**RULE NOs.: R161-16.21
 & R161-16.22**

NOTICE OF PROPOSED RULE

R161-16.22: Revisions to the Standards Manual as follows:

CITY OF AUSTIN
WATERSHED PROTECTION DEPARTMENT

STANDARD NO.
625S-2.A

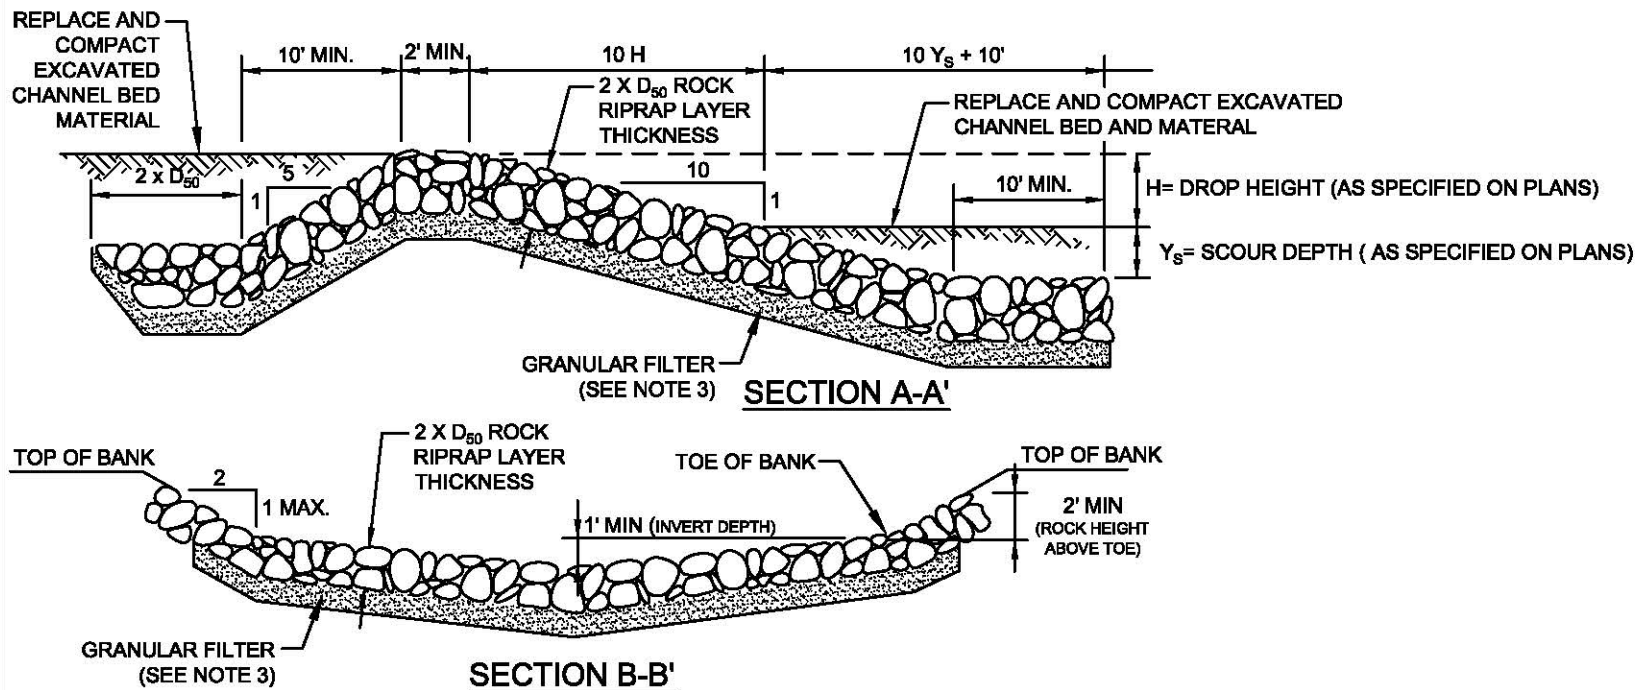
- **625S-2A** – Grade Control Riffle Structure with Embedded Toe
- **625S-2B** – Grade Control Structure Rock Riffle with Preformed Scour Pool
- **625S-3A** - Grade Control Structure Rock Riffle with Concrete Crest and Embedded Toe
- **625S-3B** - Grade Control Structure Rock Riffle with Concrete Crest and Preformed Scour Pool
- **625S-4A** - Grade Control Structure Rock Riffle with Boulder Crest and Embedded Toe
- **625S-4B** - Grade Control Structure Rock Riffle with Boulder Crest and Preformed Scour Pool
- **625S-5A** - Grade Control Structure Rock Riffle with Wastewater Crossing and Embedded Toe
- **625S-5B** - Grade Control Structure Rock Riffle with Wastewater Crossing with Preformed Scour Pool
- **625S-6** – Straight Stepped Rock Drop

Add new detail

STANDARD NO.
625S-3.B

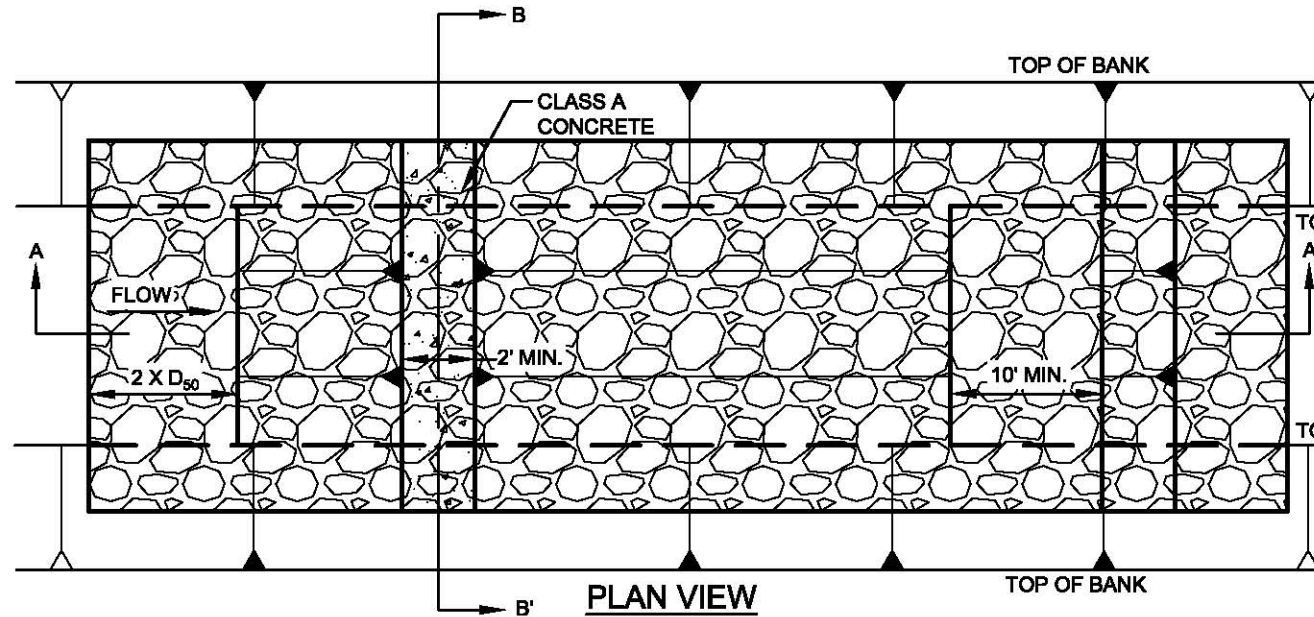
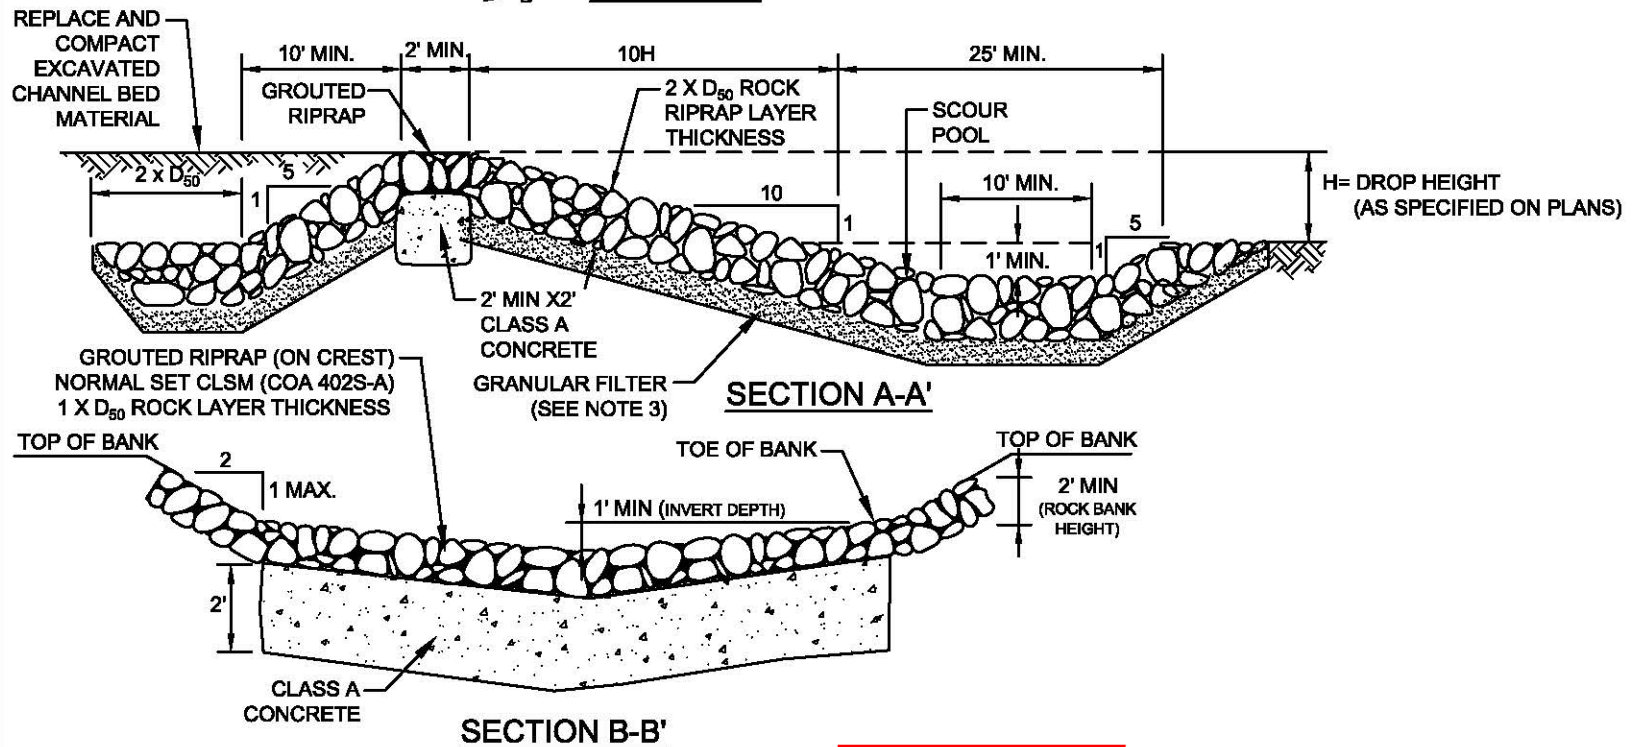
Add new detail

STANDARD NO.
625S-4.B

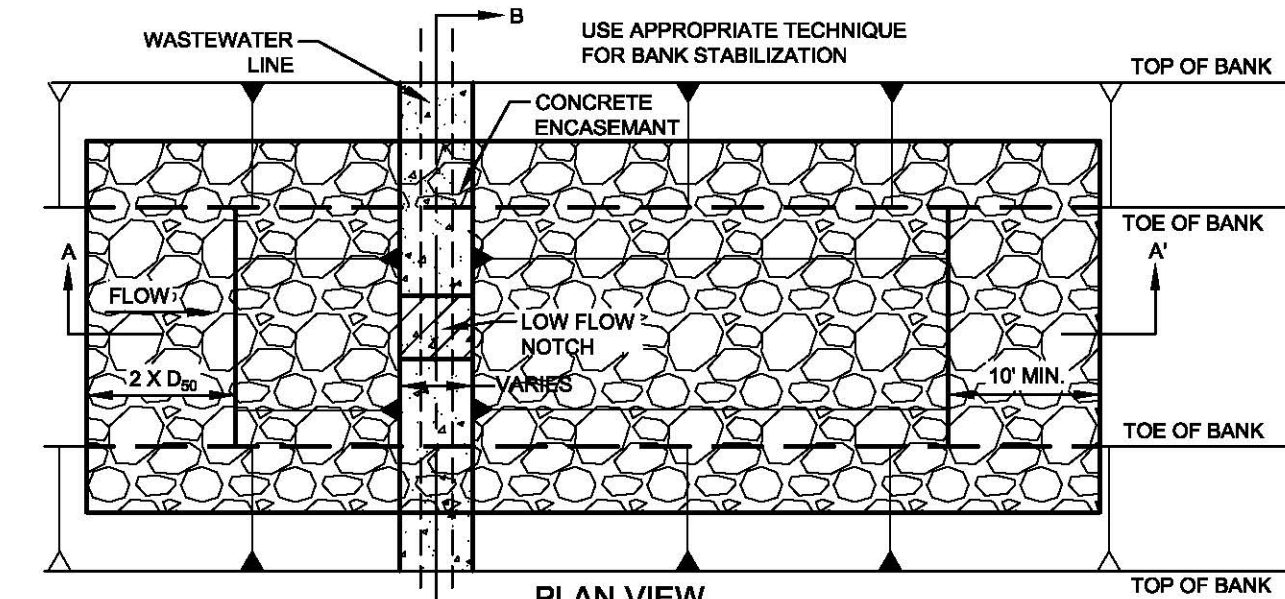
Add new detail

STANDARD NO.
625S-5.A

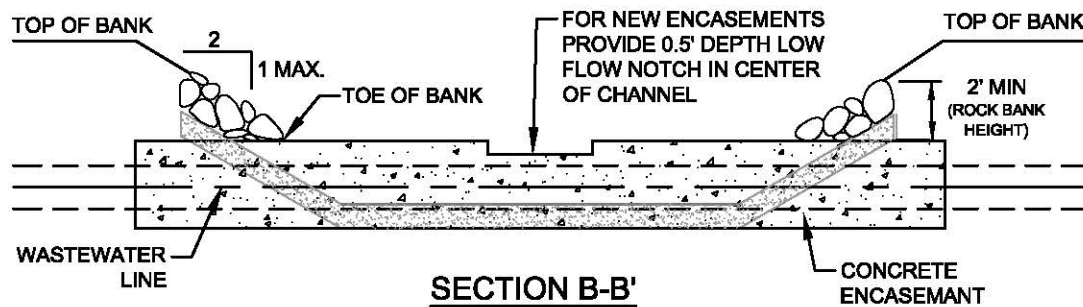
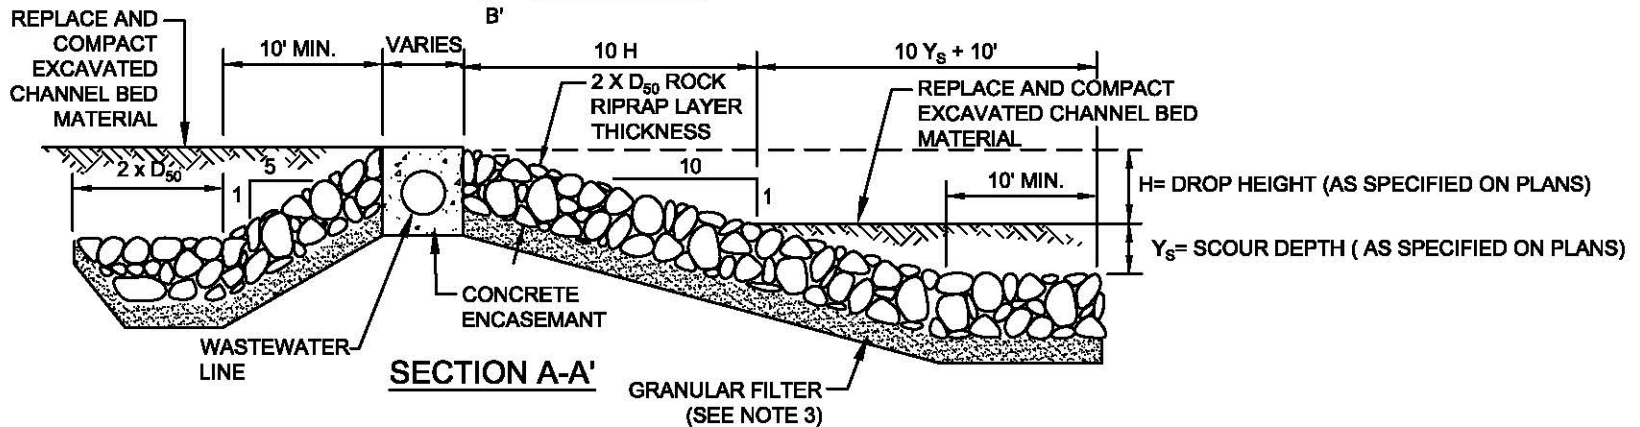
Add new detail

STANDARD NO.
625S-6

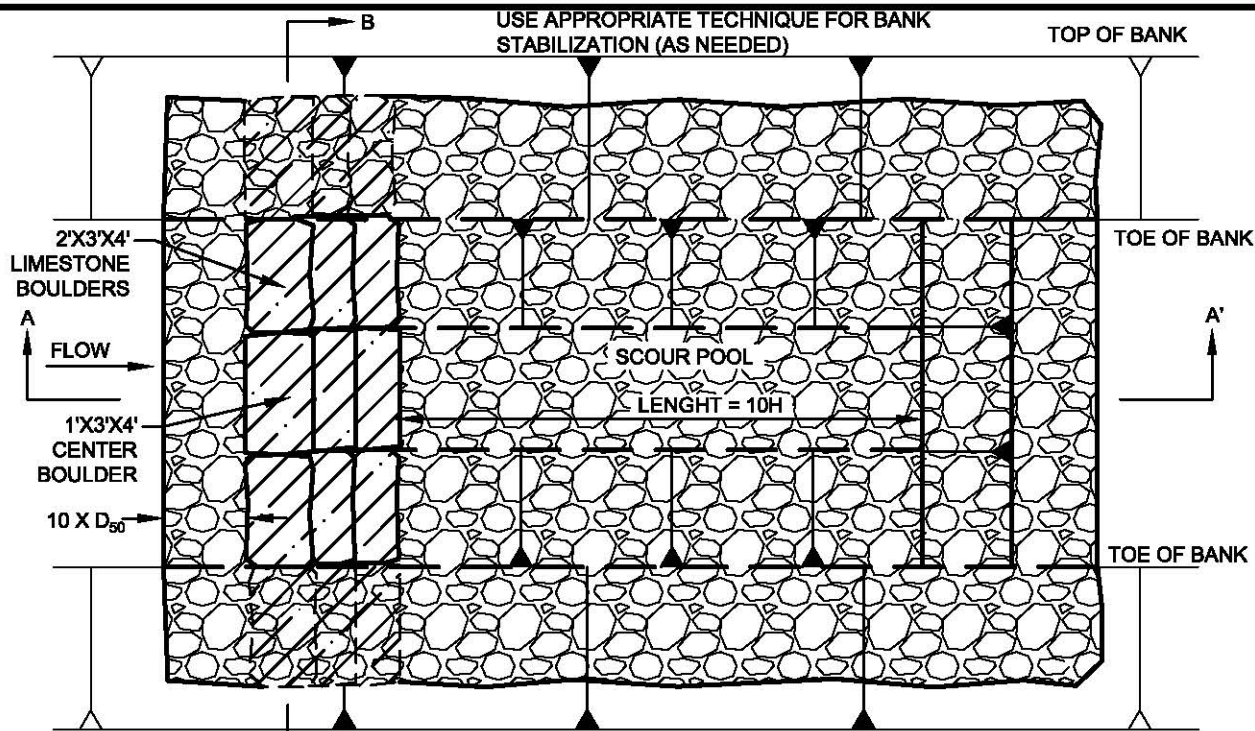
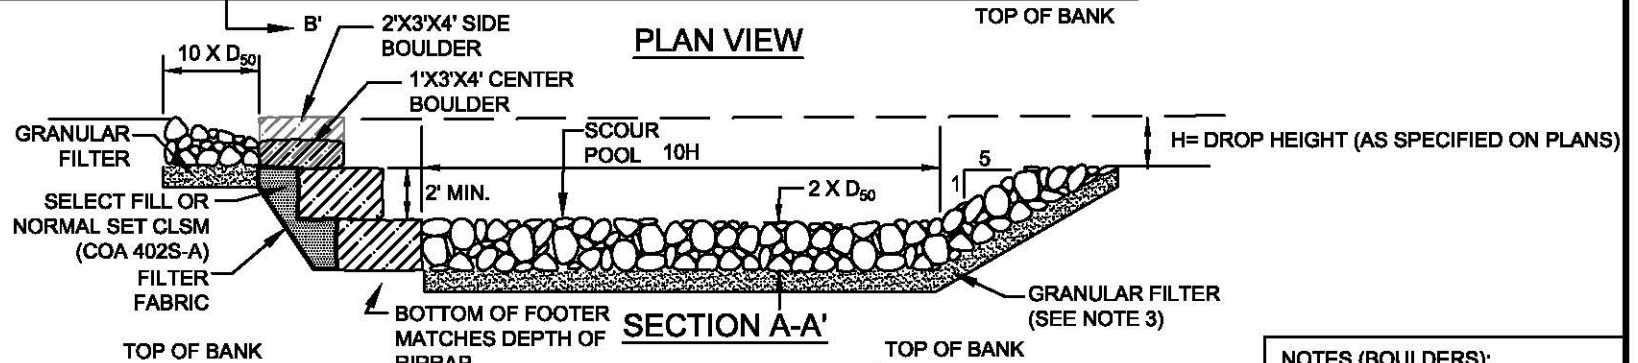
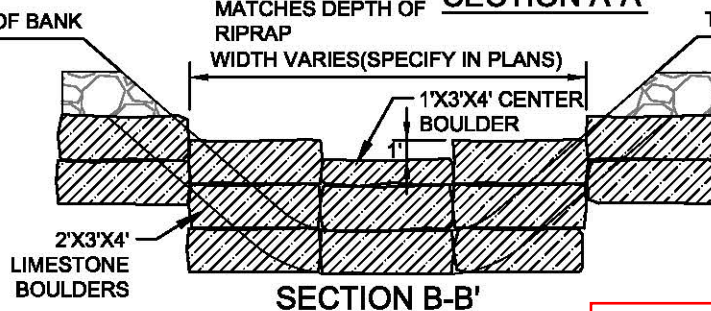
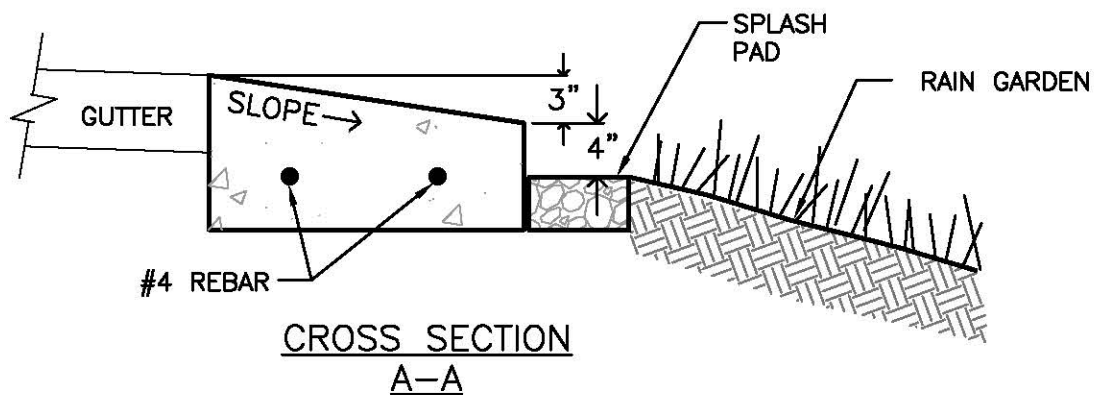
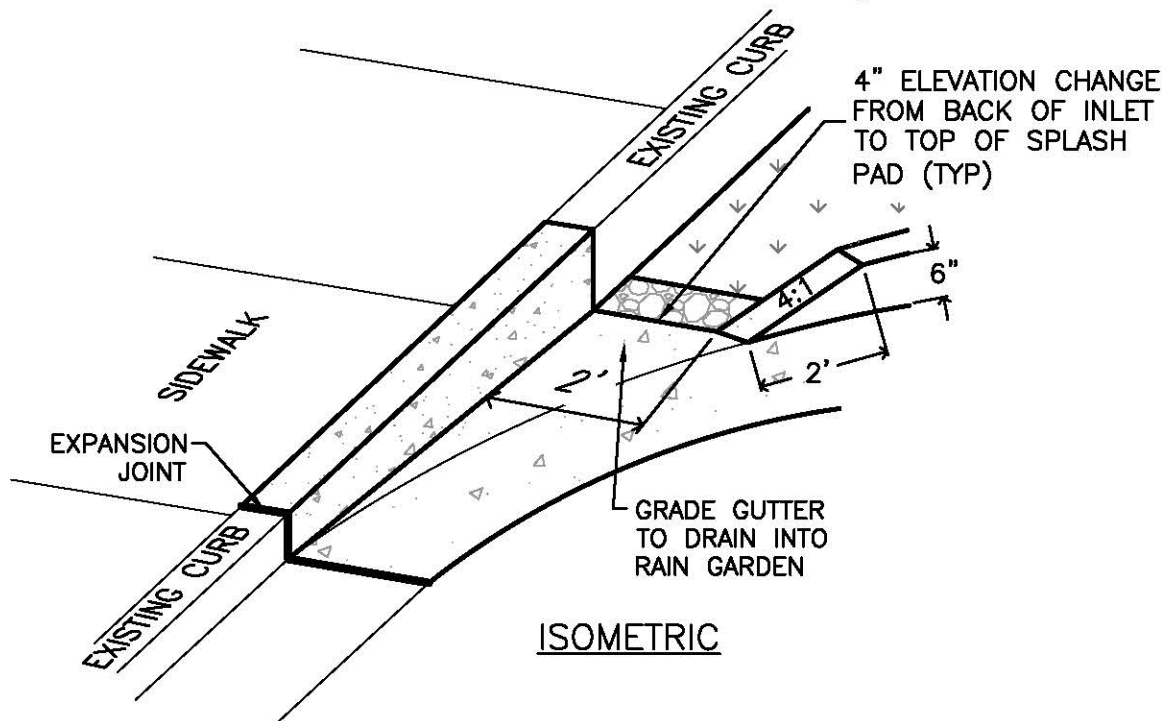
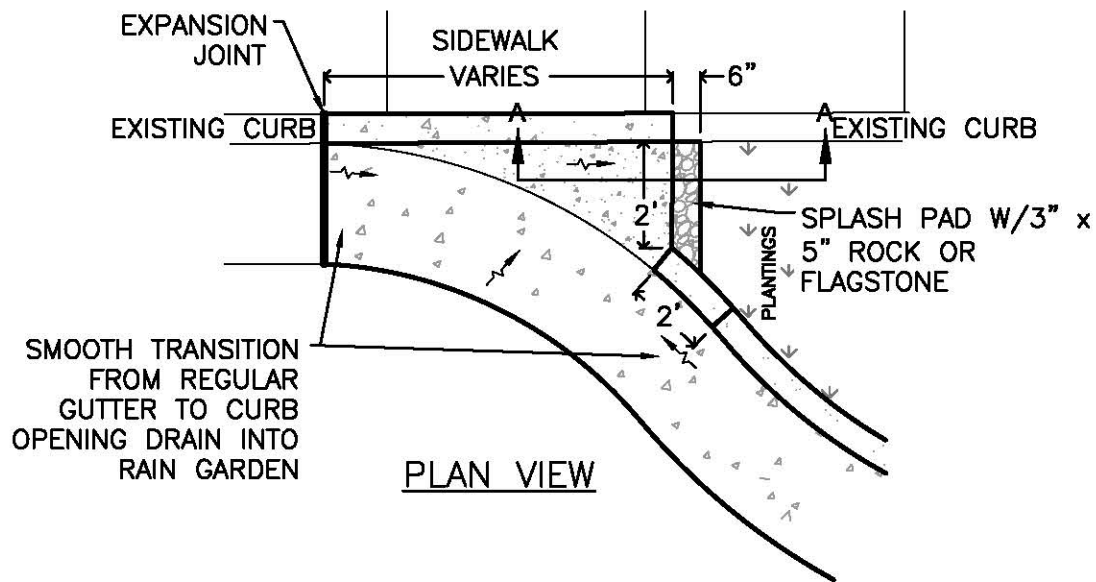
Add new detail

RAIN GARDEN
TYPICAL INLET DETAIL 1

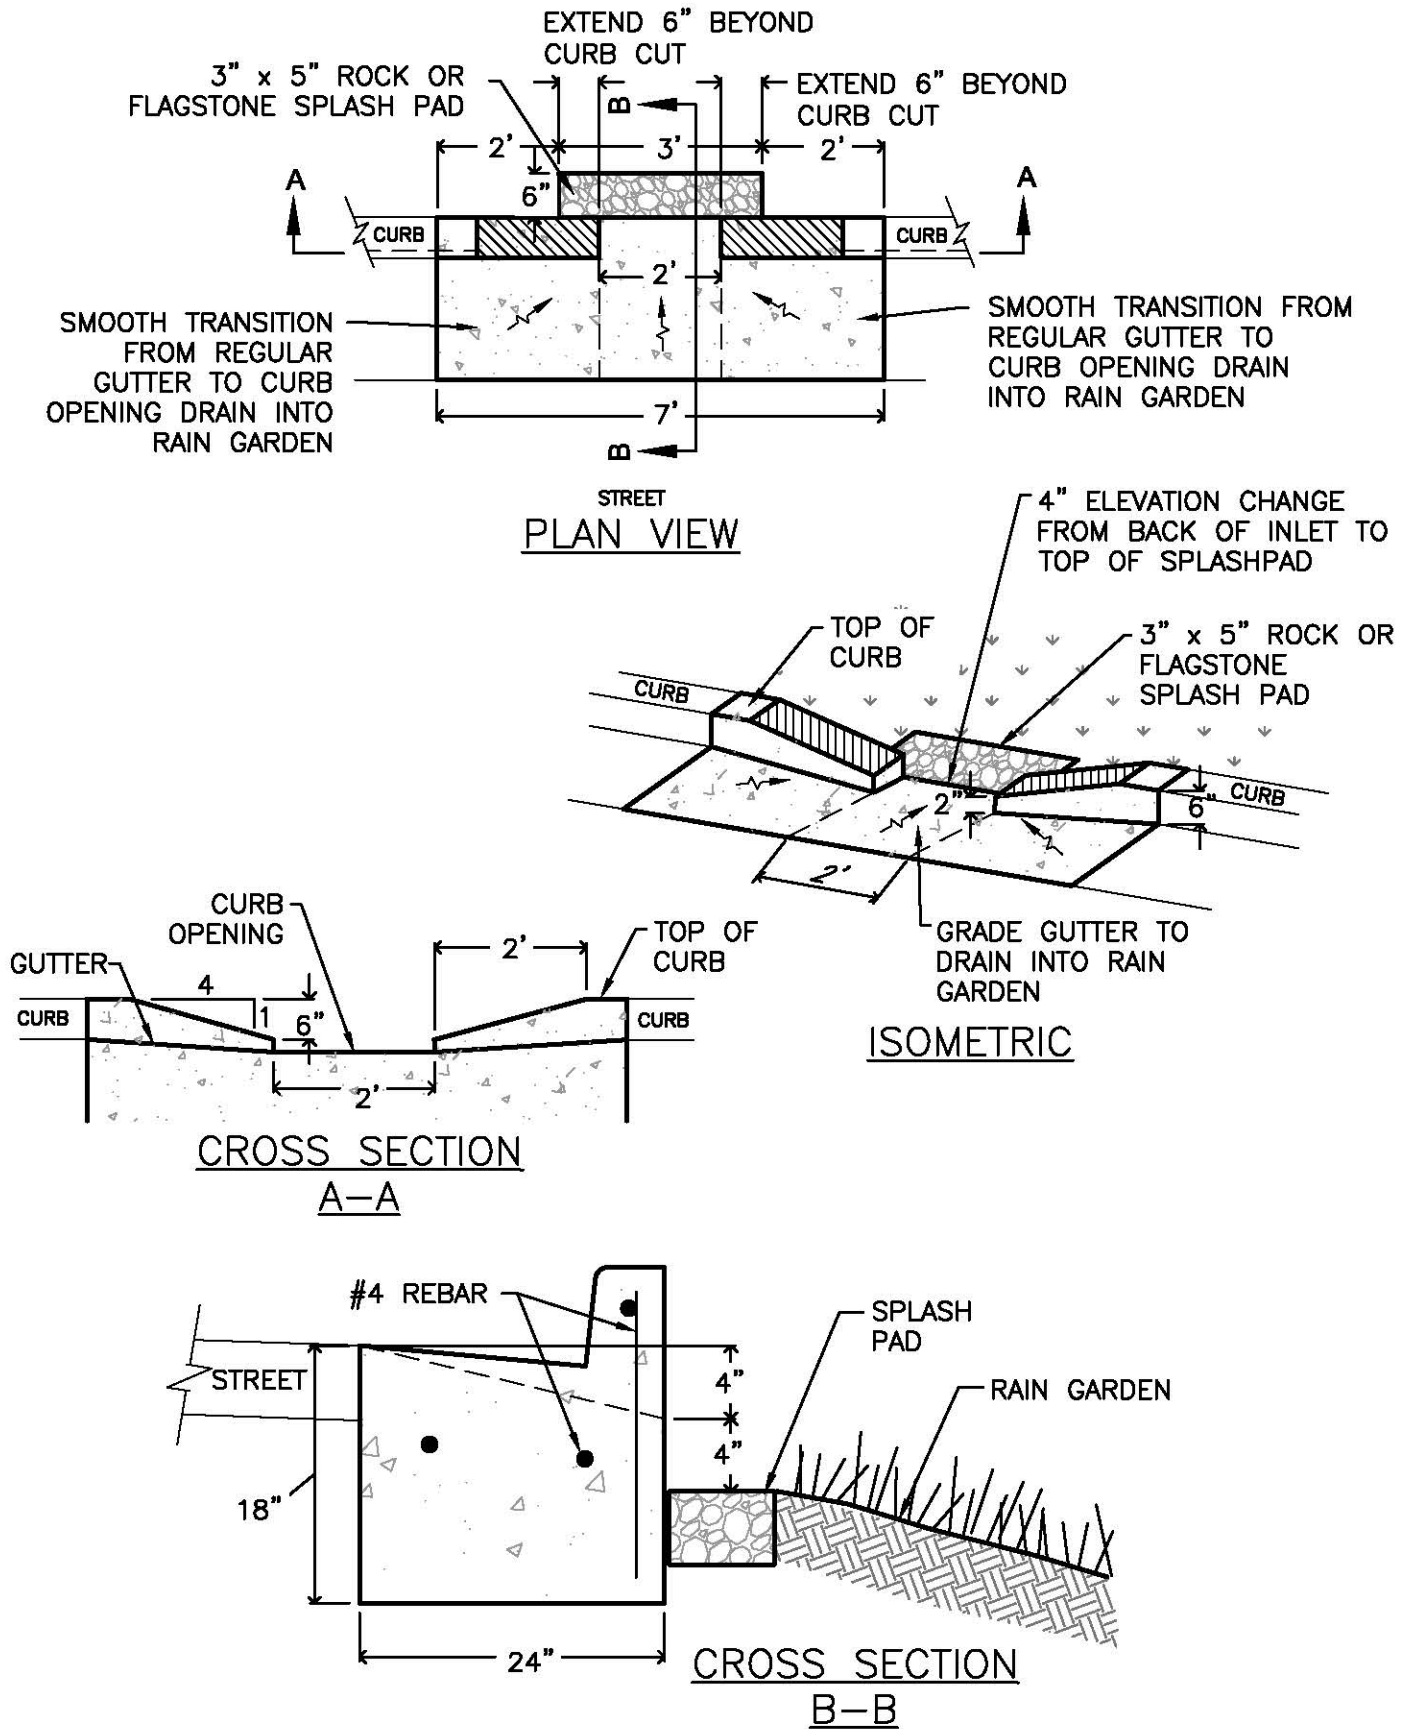
SPD 660-3 and SPD 660-4 – Rain Garden Typical Inlet Details 1 and 2

- Reduced splash pad area and provided dimensions for drop from back of curb to top of splash pad area to improve function and reduce maintenance of rain gardens.

Replace existing with this detail
